Office Action Summary

10/686,294

DRIGGERS, MATT G.

DETAILED ACTION

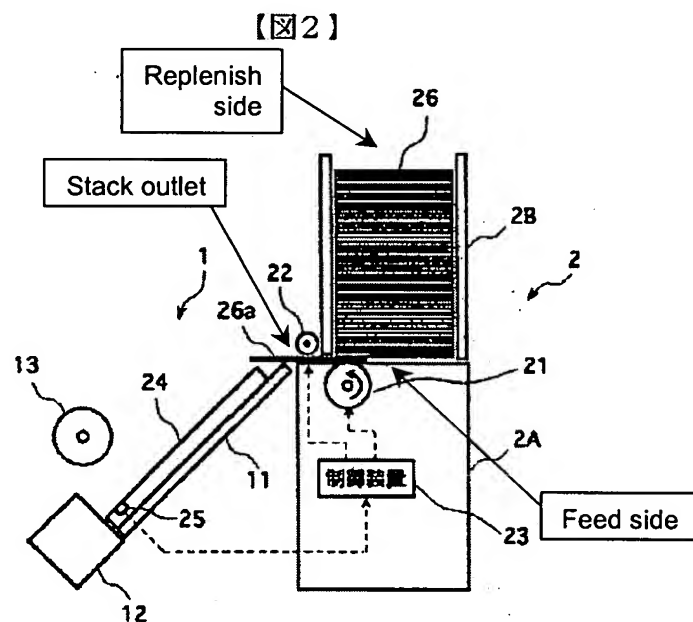
With respect to claims 1 and 20, Okada discloses an infeed module (or stack accessory) used with a printer including a mounting structure (not shown, see paragraph [0008], lines 1-2 of the machine translation of Okada) that is selectively attachable at a mounting site of a printer, a media stack receptacle 2B with a feed side and a replenish side and a stack outlet adjacent the feed side as shown in the Figure below taken from Figure 2 of Okada:

With respect to claim 2, the outlet includes a feed wheel 21.

With respect to claim 9, the replenish side of the stack receptacle is on the upper side as shown in Figure 2 of Okada.

With respect to claim 10, the feed side of the stack receptacle is on the bottom side as shown in Figure 2 of Okada.

With respect to claim 11, the replenish side of the stack receptacle is on the upper side, and the feed side of the stack receptacle is on the bottom side as shown in Figure 2 of Okada.

With respect to claim 21, the stack accessory defines a media feed path at least past roller 22 and down onto tray adapter 24 as shown in Figure 2 of Okada.

With respect to claim 22, the feed path includes a first portion defined by the bottom of the stack accessory at least past the roller 22 and a second portion defined by the printer which includes tray adapter 24.

With respect to claim 25, the stack accessory propels media therefrom a fixed distance; the distance from the outlet to the stop 12 as shown in Figure 2 of Okada.

FIG. 2

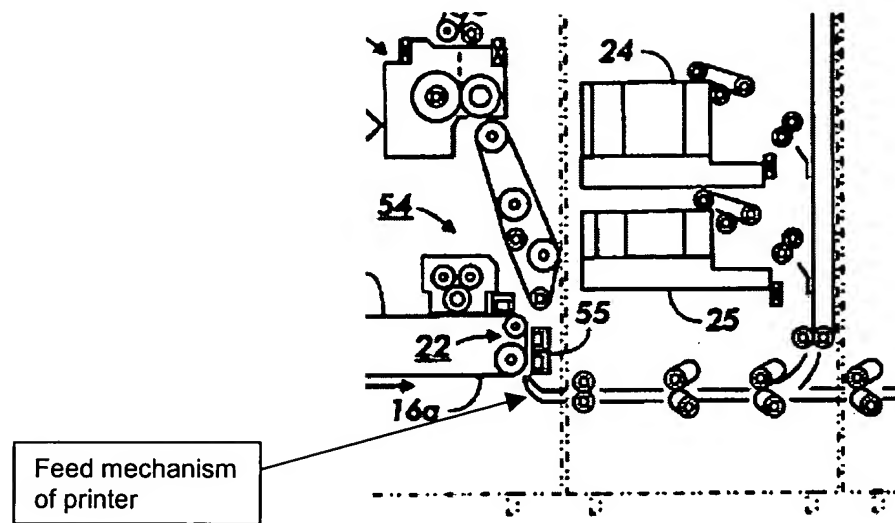
With respect to claim 14, Stemmle discloses the claimed method of printer operation except for the stack accessory having an open replenish side. Stemmle discloses a printer 10 in combination with a stack accessory 30 that is selectively attached to the printer 10 as shown in Figures 1 and 2 of Stemmle. The stack accessory passes a sequence of media from a stack receptacle 24 into a feed mechanism of the printer 10 as shown below in the Figure taken from Figure 2 of Stemmle:

FIG. 1

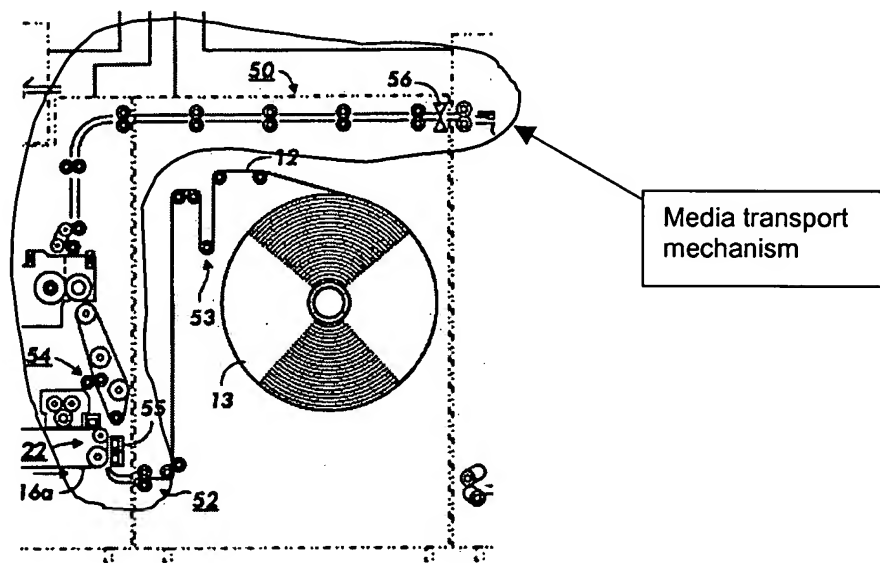
Stemmler further discloses a media transport mechanism as shown below in the Figure taken from

Figure 1 of Stemmler:

the step of removing a first portion of the media transport mechanism (the portion in section 50-section 50 being removed) and replacing it with a stack accessory 30 as shown in Figure 2 of Stemmler. The stack accessory complements the second portion of the media transport mechanism (the portion in the printer 10) in the sense that it completes the media transport mechanism.

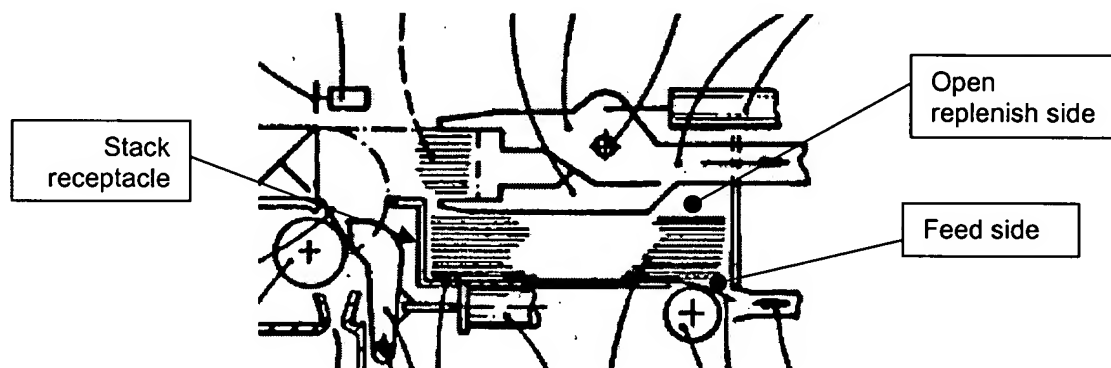
It is not known to the examiner if the stack receptacle 24 has an open replenish side. However, Ettischer et al. discloses a printer including a stack receptacle 7 with an open replenish side and a feed side opposite the replenish side as shown below in the Figure taken from Figure 1 of Ettischer et al.:

With respect to claim 16, the above Figure from Ettischer et al. shows the step of replenishing the stack receptacle at its replenish side.
